Remedies for comments #105, #106, #107  
IEEE802.3bt Draft 2.1 Annex 33C

Miklos Lukacs (Silicon Labs) | 04 Nov 2016

# Connection Check sequence diagrams

Figure 33C-2—PSE implementing CC\_DET\_SEQ=0, do\_cxn\_chk result is dual, simultaneous power on

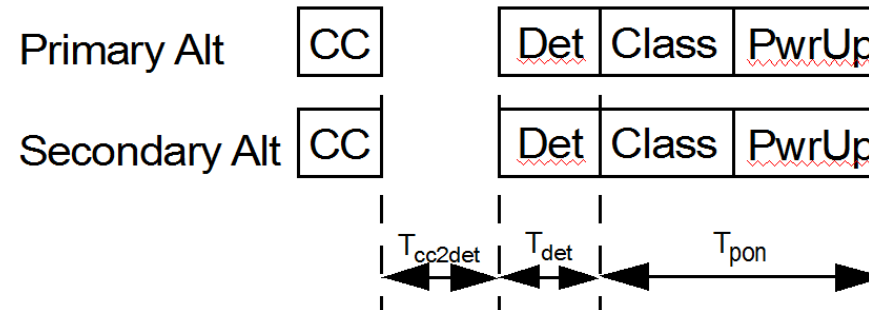
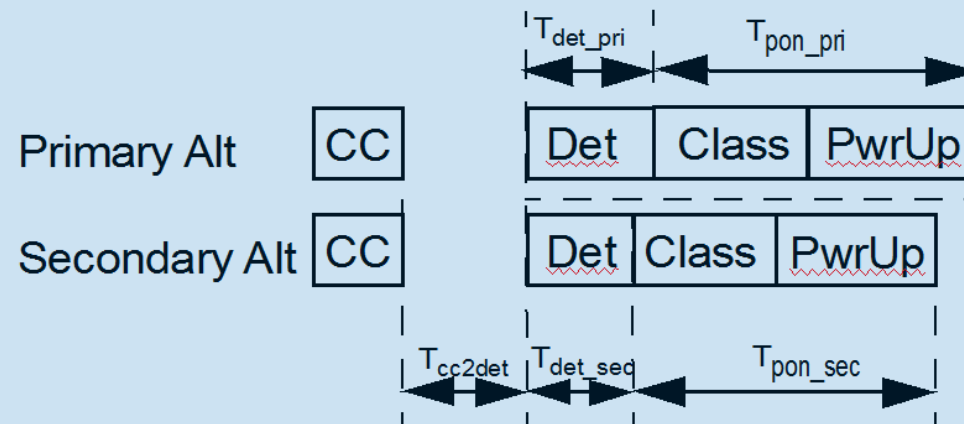
# CC\_DET\_SEQ=0 when the result of connection check is dual and Class\_4PID\_mult\_events\_sec is TRUE

comments #106,107

Figure 33C-2 in Draft 2.1

Proposed new Figure 33C-2

Figure 33C-2—PSE implementing CC\_DET\_SEQ=0, do\_cxn\_chk result is dual

Figure 33C-13—PSE Single-Event Physical Layer classification

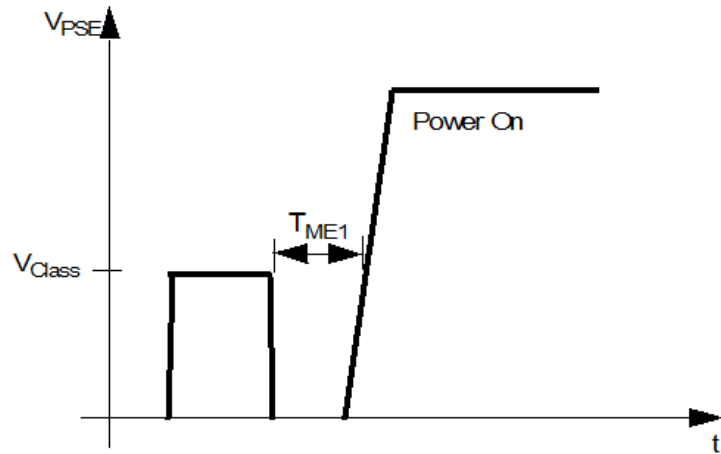
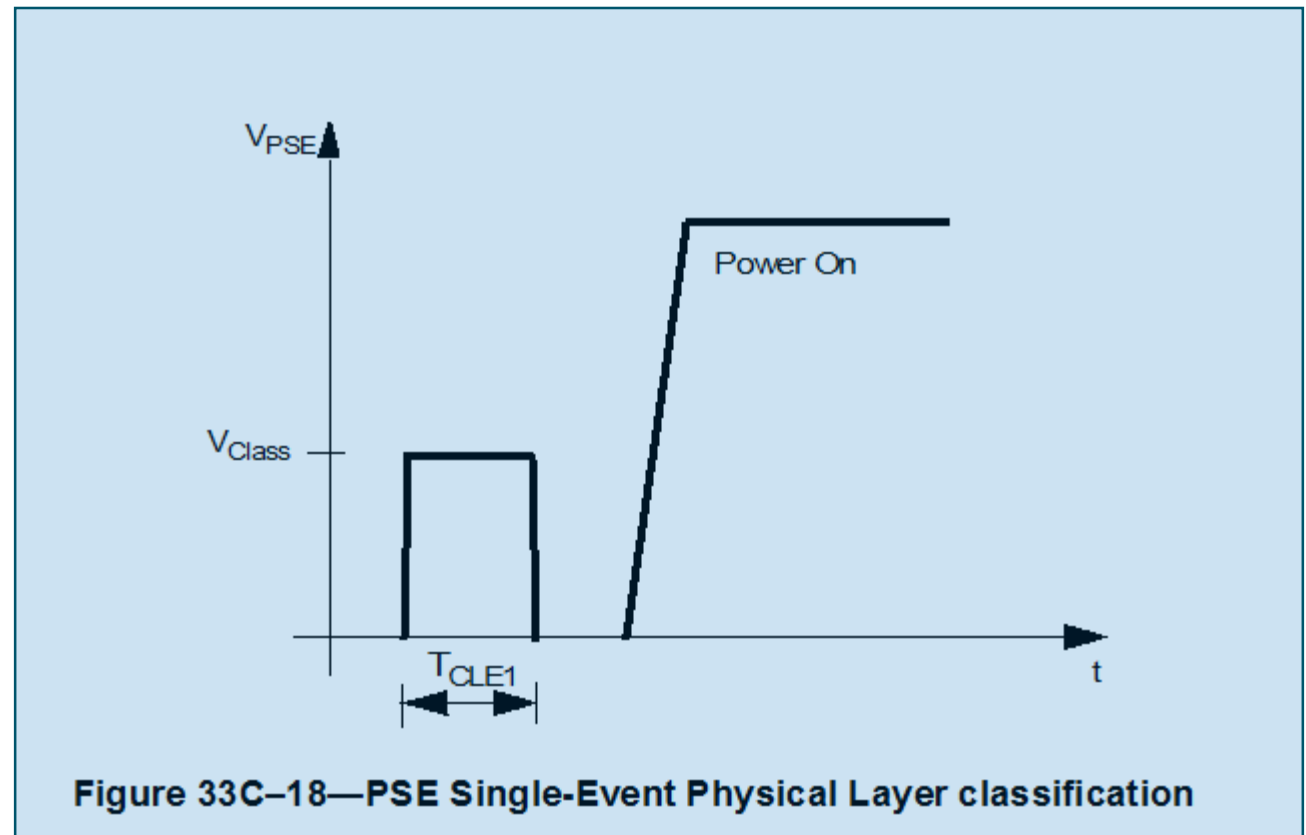
# Single-Event classification

comment #105

Figure 33C-13 in Draft 2.1

Proposed new Figure 33C-13

Figure 33C-18—PSE Single-Event Physical Layer classification
